RE: Responses to November 20, 2018 Adequacy Review Letter, Bad Boys Pit M-1996-081, Teller County, Colorado

Response to Elliot Russell Adequacy Review Letter Dated November 20, 2018
Permit No. M-1996-081
By: C. A. Braun, November 21, 2018

Exhibit Map E
Showing Existing Site with Improvements
Cripple Creek Project

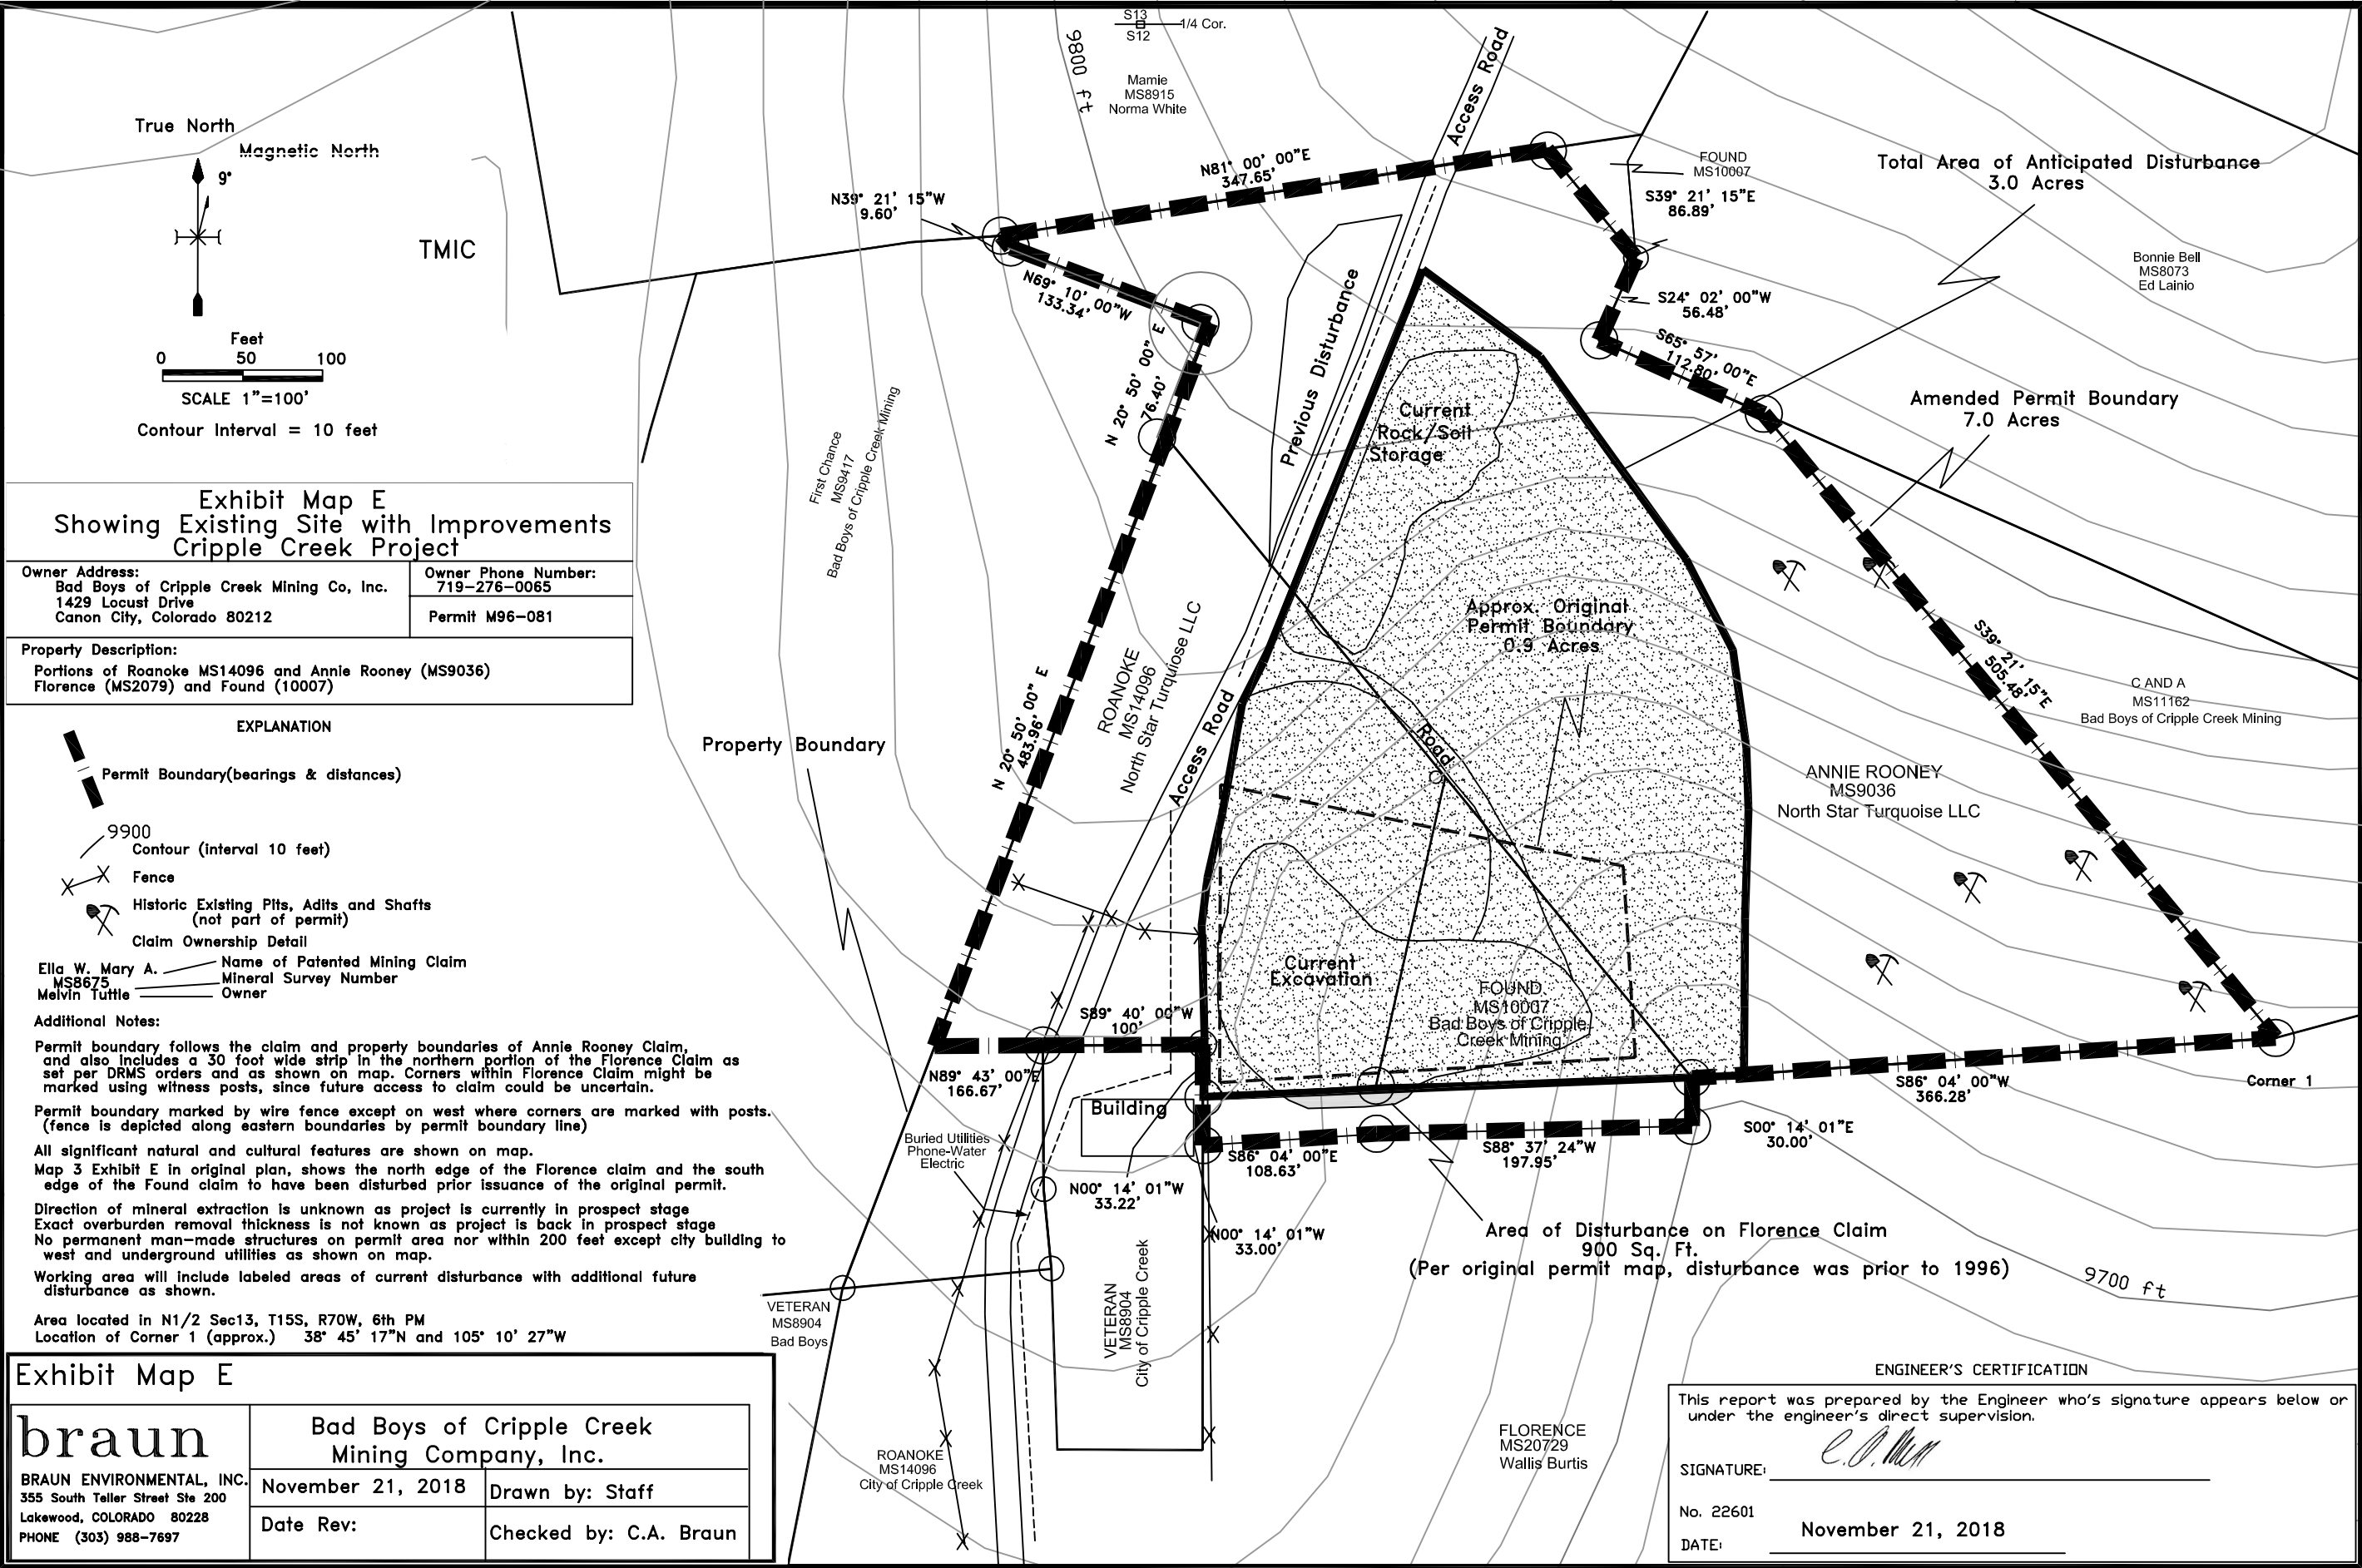
Comment 24: *The revised Exhibit E Map still contains an error within the Additional Notes section. The Division believes there is a typo regarding the statement that the permit boundary "includes a 30 foot wide strip in the northern portion of the Found Claim". The Division believes this should actually be the northern portion of the Florence Claim. Please update this map and re-submit it for further review.*

Response: Thanks for the detailed review. This error has been corrected.

Exhibit Map E-1 Reclamation Map

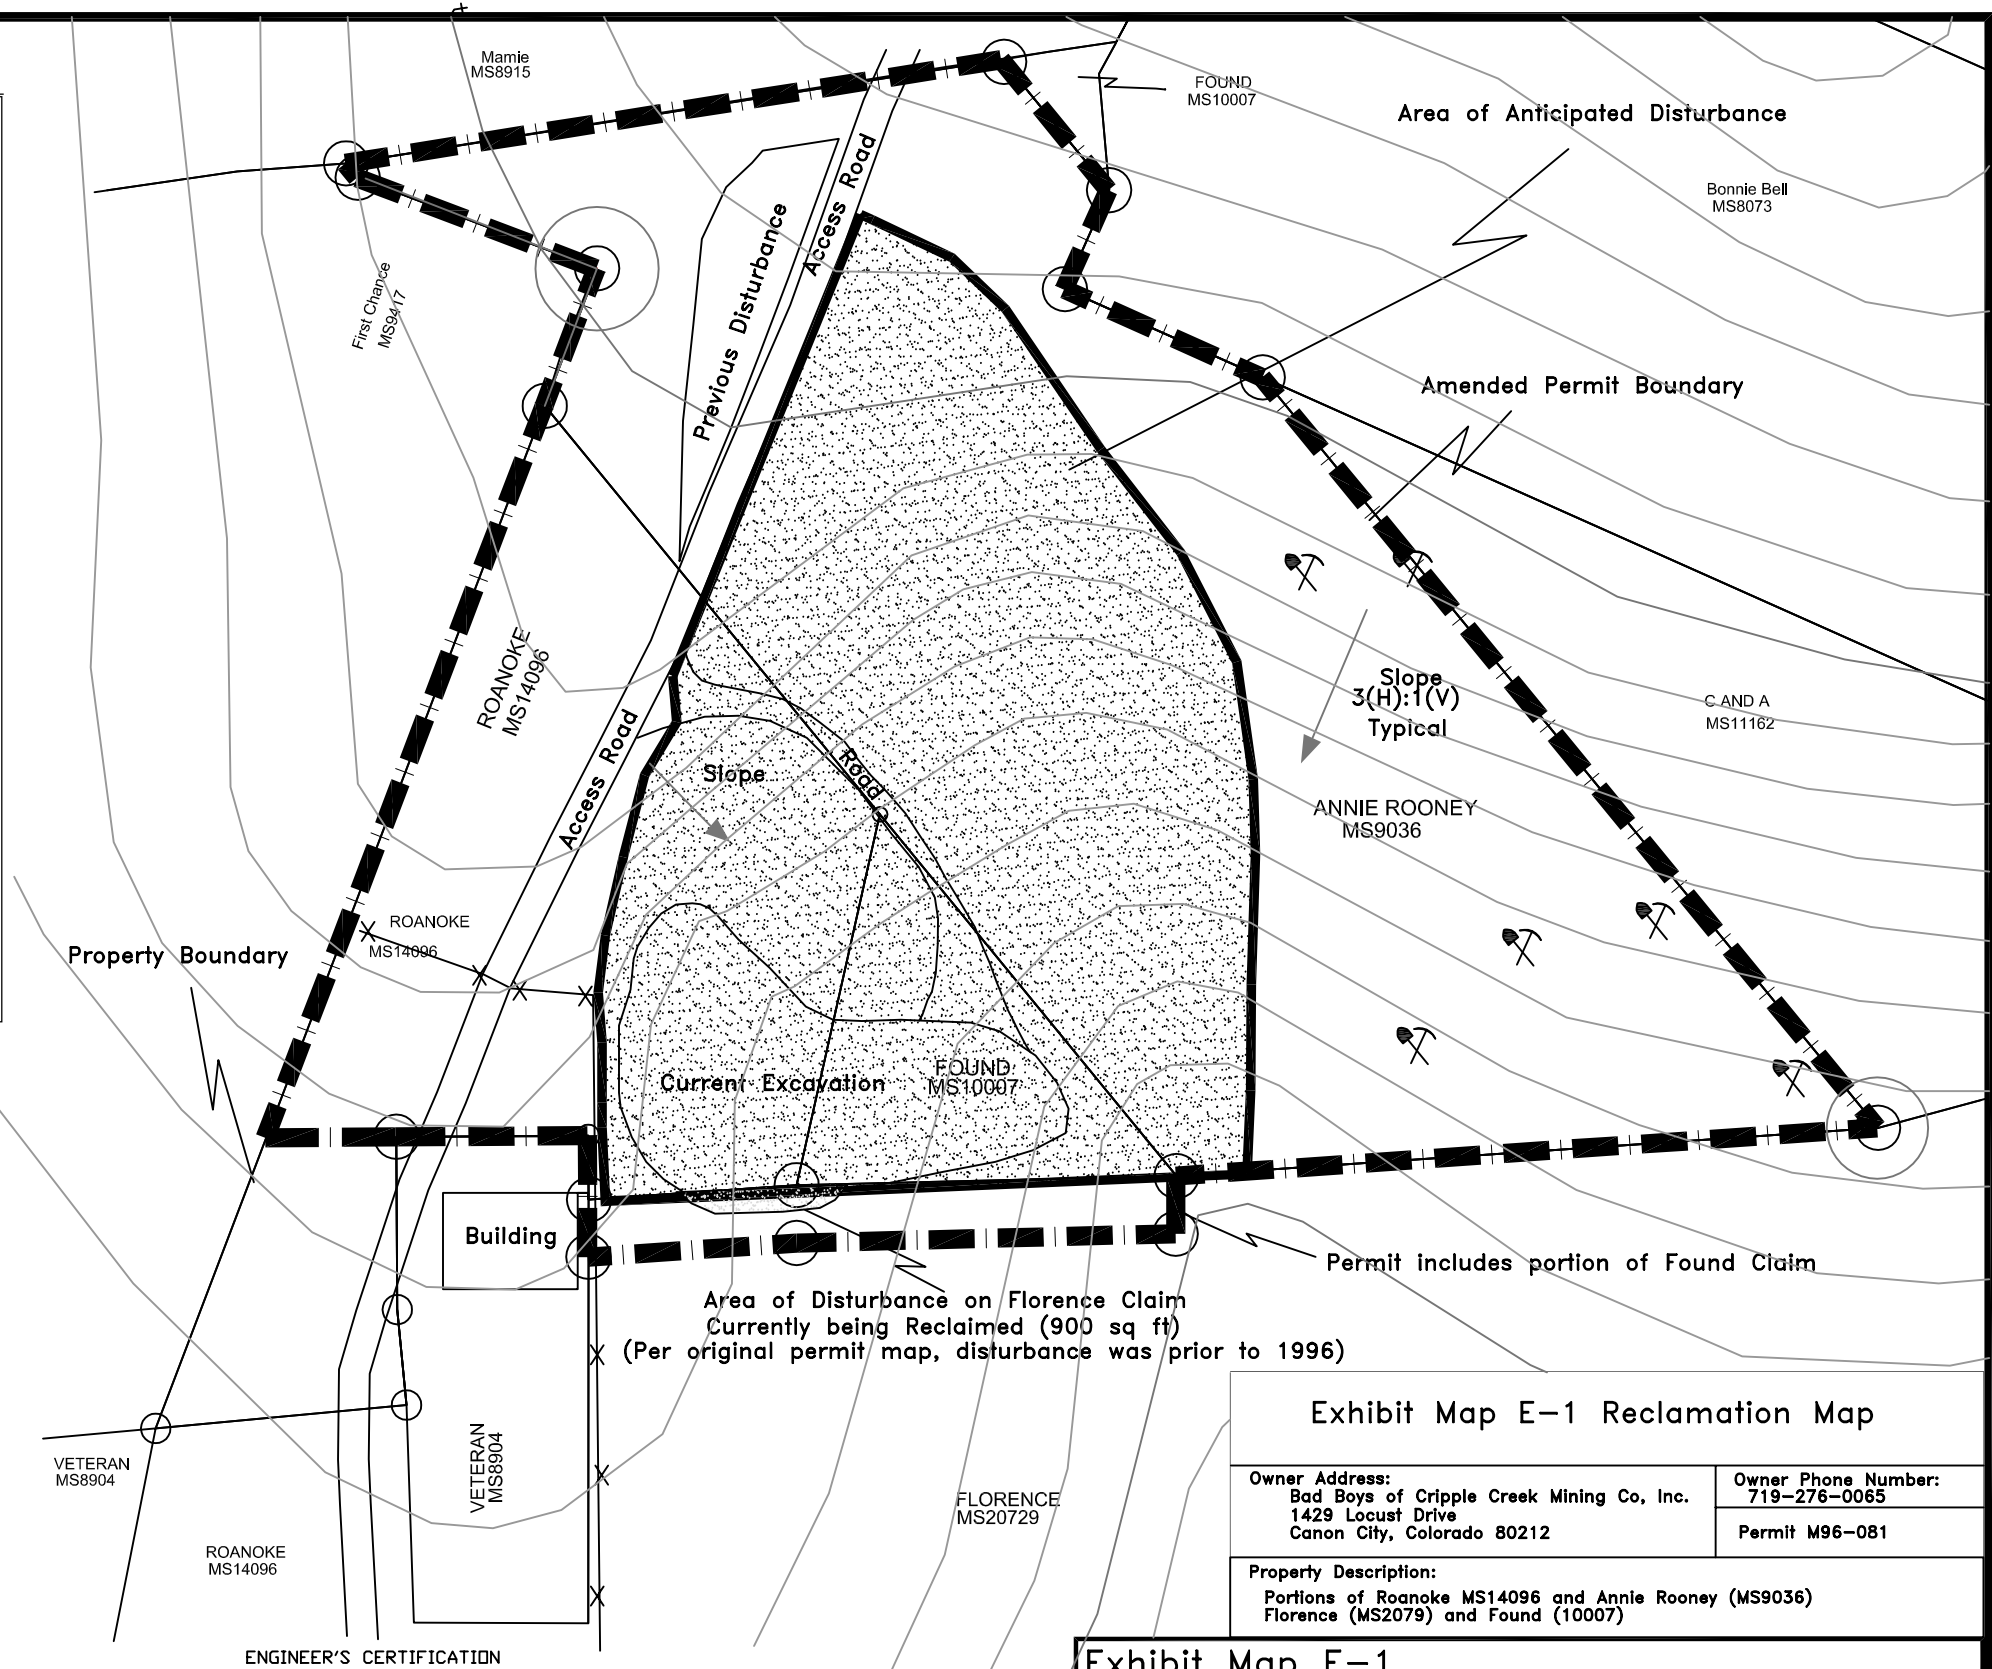
Comment 25: *The Final Reclamation Plan Map depicts the final site configuration and remaining features after all mining and reclamation has been completed. Please remove the Current Excavation and Current Rock/Soil Storage polygons and labels from the Exhibit Map E-1 as these features will not remain after final reclamation.*

Comment 26: *The Division believes there is an error regarding the reclaimed slope gradient labels on the Exhibit Map E-1. The eastern label states "Slope 1(H):3(V) Typical", however based on the approved maximum reclaimed slope gradient of 3H:1V and topographic details of the map, the*

Division believes this should state “Slope 3(H):1(V) Typical”. In addition, the western label states “1(H):1.5(V)”, however this does not match the approved maximum reclaimed slope gradient of 3H:1V nor the topographic details of the map. Please revise these labels accordingly.

Comment 27: In accordance with Rule 6.3.5(3)(d), please state, on the Exhibit Map E-1, the average thickness of replaced overburden/waste rock. Please note, in the response to Adequacy Item #15g, the Applicant stated the maximum depth of the excavation is 70 feet and therefore the average thickness of replaced overburden/waste rock would be 35 feet. Please revise this to reflect the maximum approved depth of 50 feet. It may be most appropriate in this case to state on the Exhibit Map E-1, similarly to the approved reclamation plan, that all excavated material will be backfilled into the pit similar to the pre-mining surface and this could be up to 50 feet thick.

Response: Per your instruction, the words have been removed.

Response: Thanks for your detailed review. The drafting error has been corrected on the 3(H): 1(V) label, and the 1.5(H): 1(V) label has been removed. The words, “All excavated material will be backfilled into the pit as similar as possible to the pre-mining surface and this could be up to 50 feet thick.” have been added to the note section of Exhibit Map E-1.

Response: The wording has been added to Exhibit Map E-1.
